TRUCK, CARGO, WITH CRANE, HEAVY, MC3 (MACK)
CO-AXIAL CAPACITOR - CAB HEATER BLOWER MOTOR

MODIFICATION INSTRUCTION

1. This instruction details the fitting of a co-axial capacitor to the cab heater blower motor to improve RFI suppression.

FIG 1 - MOUNTING OF CO-AXIAL CAPACITOR

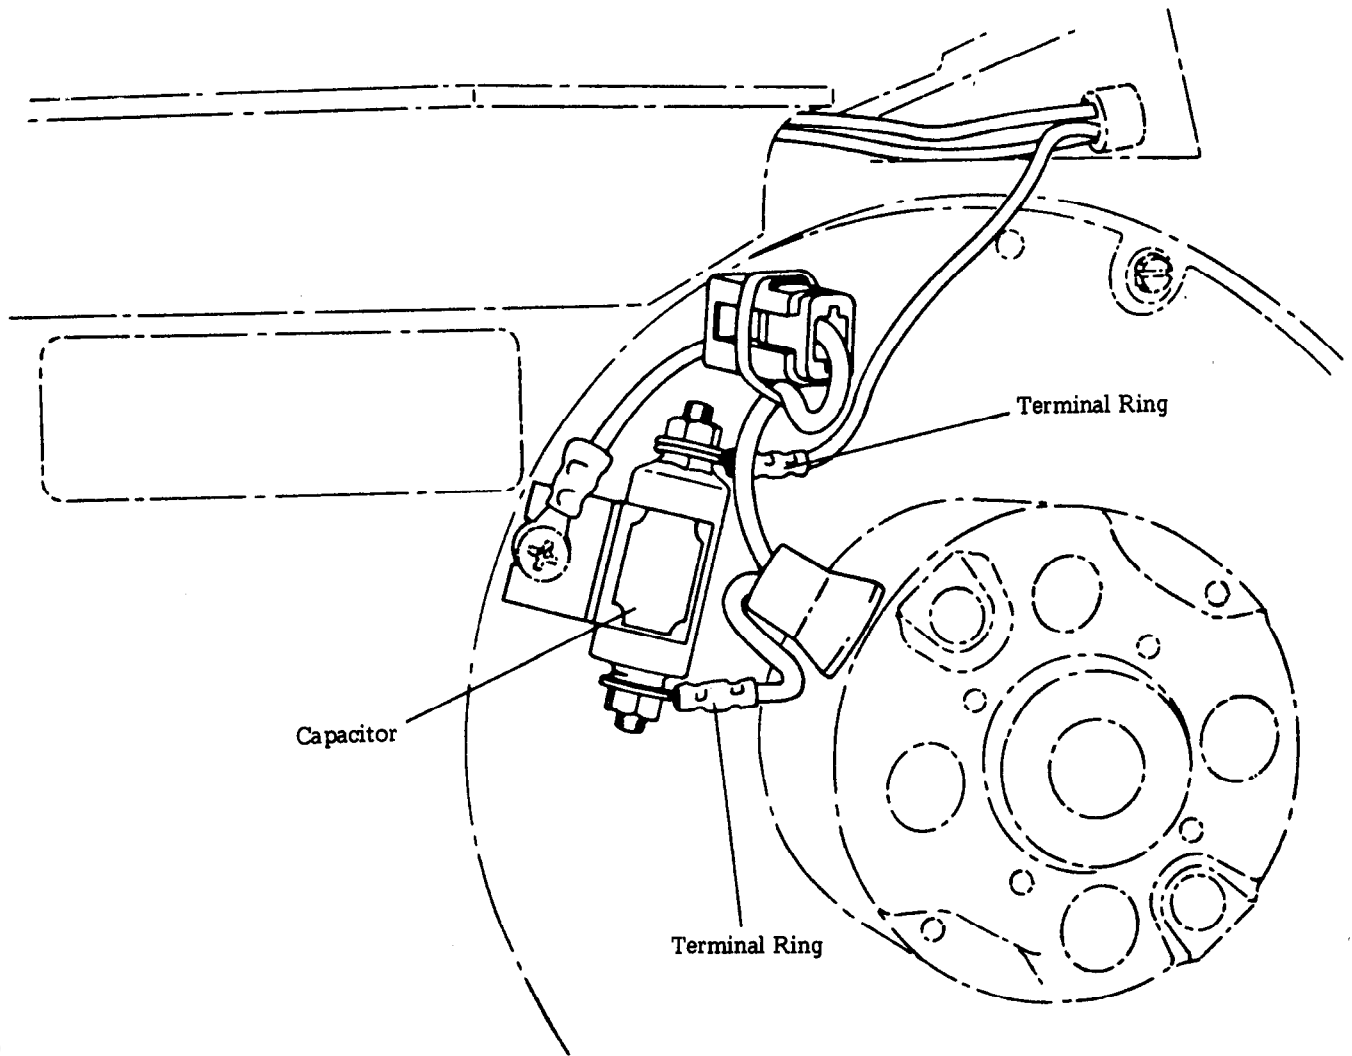
8. To carry out the modification, proceed as follows:
 - a. Trim 10 mm off the end of the capacitor, item 1 from Table 1, mounting tail
 - b. Cut the power connector from the power lead and discard it.
 - c. Crimp suitable 3/16 inch terminal rings to the ends of the power lead, as illustrated in Fig 1, and fit the leads to the capacitor.
 - d. Loosen the screw on the heater body holding the earth lead and mount the capacitor as illustrated.
